## Model #3 - Generation 2

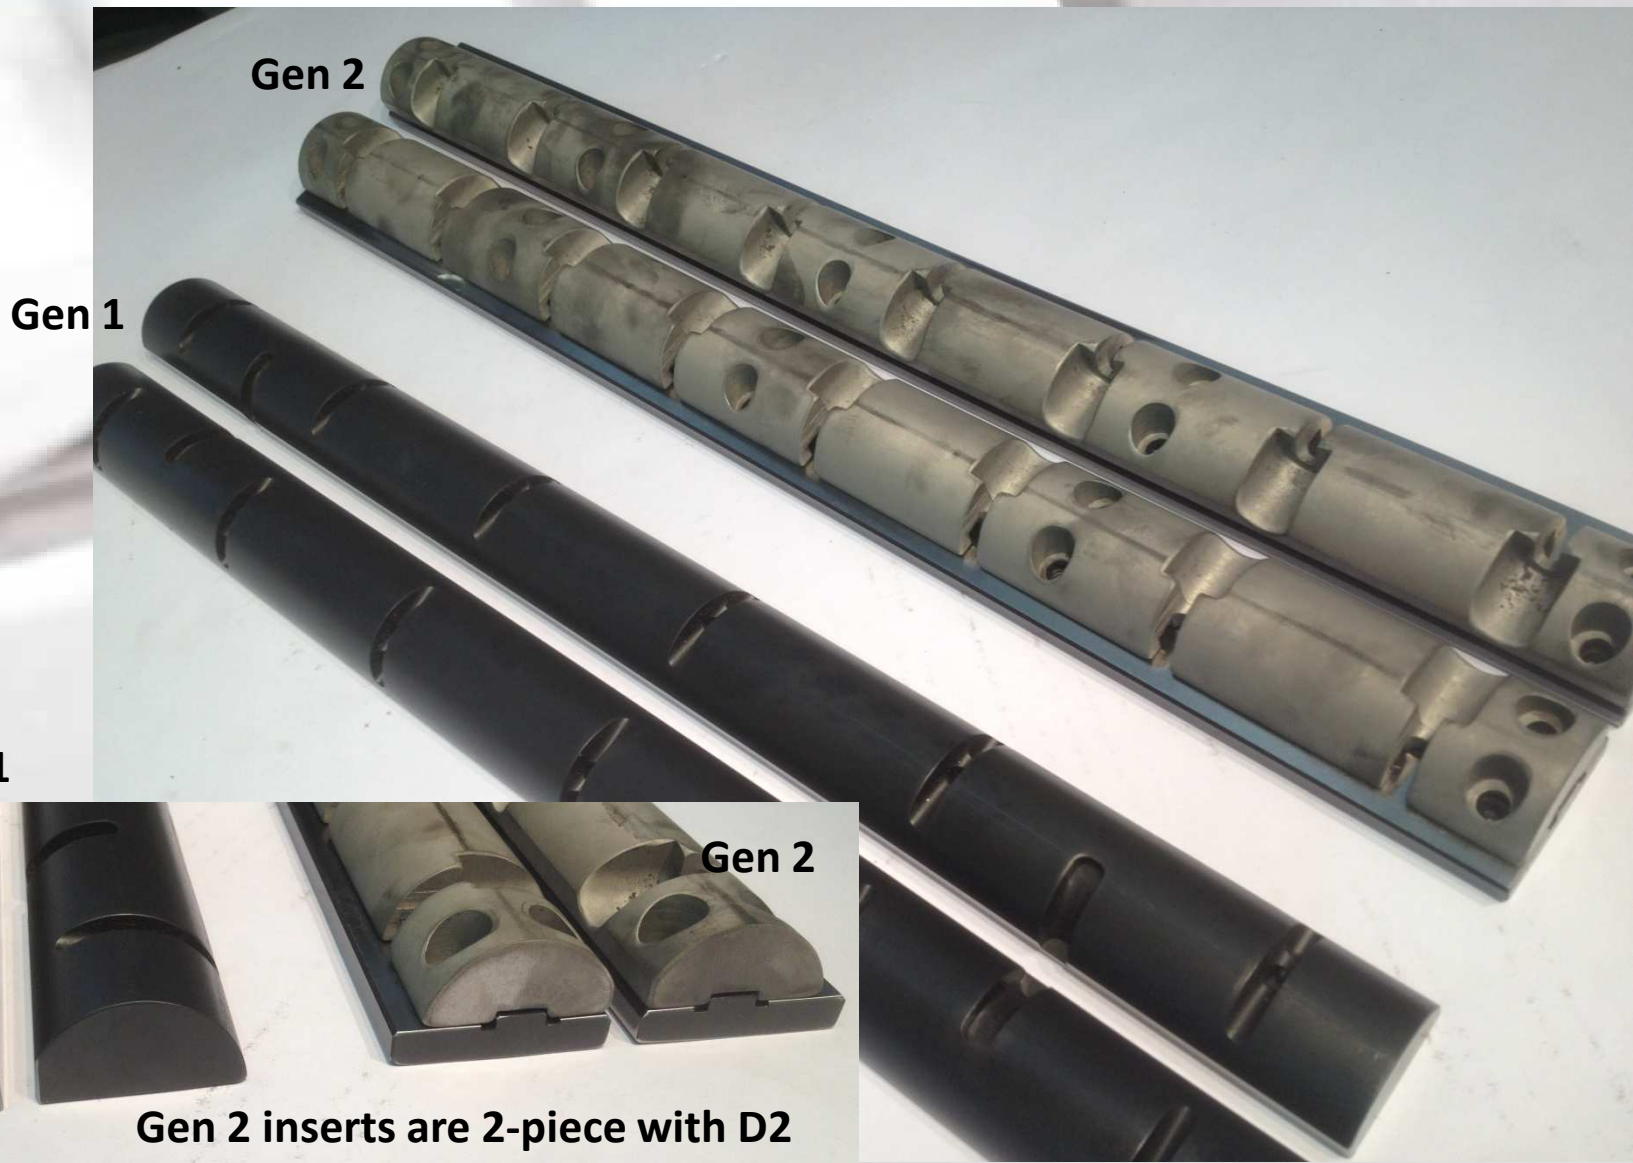
Insert retainer springs on Gen2 much stronger than Gen1 to ensure insert remains in contact with saddle during bending

Insert retainer springs increased from 12 springs per 500mm length to 16 springs per 500mm length

Lubrication 'grease-grooves' added on Gen2 for smoother operation

**Gen 2 inserts are 2-piece with D2 top plate for high durability**

**old-style model#3  
umbrella type  
compression spring  
12 springs per 500mm tool**

**new-style model#3  
tension type spring  
16 springs per 500mm  
tool length**
